HINCKLEY NATIONAL RAIL FREIGHT INTERCHANGE – LAND WEST OF STONEY STANTON

RELEVANT REPRESENTATIONS

TECHNICAL NOTE

UPDATED REVIEW OF DCO TRANSPORT ASSESSMENT

Figure 1

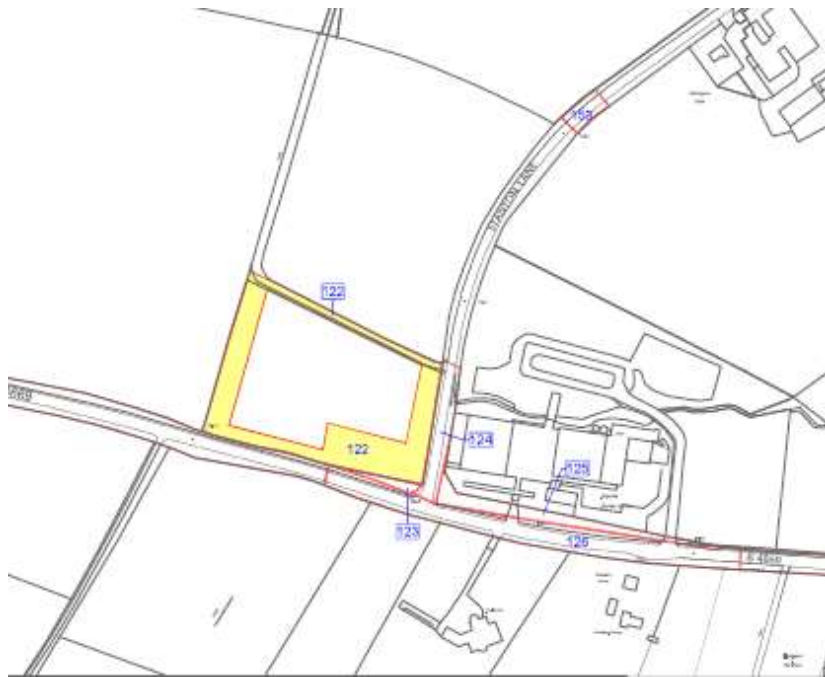
- 4.1. A large area of the Site adjacent to the highway works at Junction 19 – B4669/Stanton Lane is shown shaded yellow at Figure 1 and is included within the DCO land. It is owned by Ms Taylor. From a review of the DCO application documents, it is unclear why that is the case when the only works in the area are new traffic signals at the junction and some minor works on the B4669 Hinckley Road.
- 4.2. Reference is made within Schedule 10 of the draft DCO to a “Construction compound and laydown area in connection with the works on the B4669 Hinckley Road and the alterations to the junction at Hinckley Road and Stanton Lane including access.”
- 4.3. However, it is not clear why the land shaded yellow has been drawn that way. It is excessive and excludes part of the Site in the middle which is effectively isolated from the remainder of the landowner’s interest. This is illogical.

- 4.4. The Statement of Reasons is also silent on why this land is included within the draft DCO and we see no justification for locating a construction compound there whilst there is a significant amount of space within the main body of the HNRFI site that could easily be utilised for such purposes.
- 4.5. Any construction compound in that area could sterilise the development of the Site on that land for a significant period of time, which would be unacceptable to the Consortium and Ms Taylor.

- 4.6. In short:
 - 4.6.1. There is no compelling case for the temporary acquisition and sterilisation of this land; and
 - 4.6.2. There are reasonable alternatives to the use of this land as a construction compound that the applicant has failed to adequately explore.
